# Wollongong Local Planning Panel Assessment Report | March 2021

<b>WLPP No.</b>	Addendum Report – 2 to WLPP Item 1 - 3 November 2020
<b>DA No.</b>	DA-2020/572
<b>Proposal</b>	Residential - multi dwelling housing - demolition of existing warehouse storage facility and construction of 12 x two storey dwellings.
<b>Property</b>	481-485 Princes Highway, WOONONA NSW 2517 Lot 1 DP 86796
<b>Applicant</b>	MMJ Wollongong
<b>Responsible Team</b>	Development Assessment and Certification – City Wide Planning Team (SG)

## ADDENDUM REPORT

PROJECT NUMBER 20106	SCALE 1:200 @ A1 1:400 @ A3	NORTH 
DRAWING NUMBER AR 0012	REVISION 01

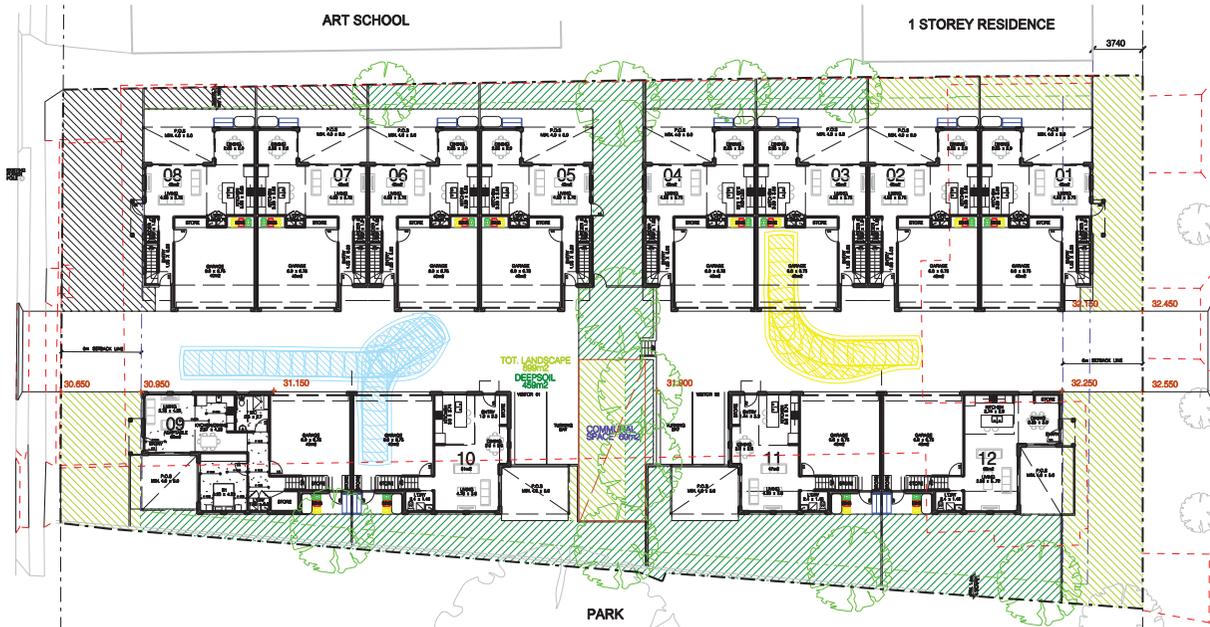
- *The proposed planting between units 6/7, 4/5, and 2/3 be low level to ensure sight lines are maintained for drivers reversing from their garages. This could form a condition in any supplementary report.*

4. The proposed planting between units 6/7, 4/5, and 2/3 be low level to ensure sight lines are maintained for drivers reversing from their garages. This could form a condition in any supplementary report

The applicant has agreed to the recommended plan changes listed above and this has been included as a condition of consent. See Revised condition 9 and 23 at Attachment 8. It is the Council's Assessing Officer's view that the condition adequately addresses the Panel's recommendations.

In relation to the other matters raised by the panel, we accept conditions to be imposed for the pergola relocation, motorbike park deletion/landscaping replacement, and low level plantings requested.
